State Environmental Planning Policy (Transport and Infrastructure) 2021
State Significant Development Application - SSD-63168959
269 Lane Cove Road, Macquarie Park
Request for additional information

9 September 2024

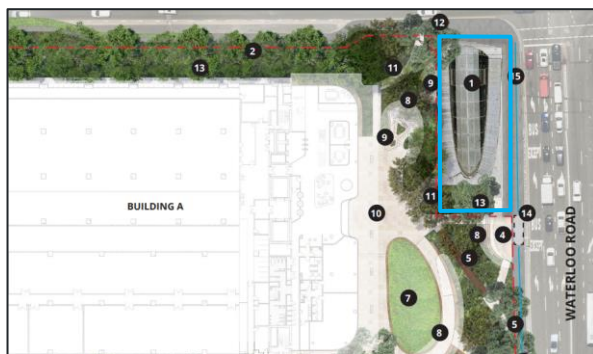
- j) Clarify if the extent of landscaping will be beyond the proposed site boundary and entering Sydney Metro's License Maintenance Area (LMA) land, shown in blue on the below extract. Should the proposed landscaping encroach Sydney Metro's LMA land, the Applicant must consult with Sydney Metro and its operator regarding maintenance and any other necessary processes.
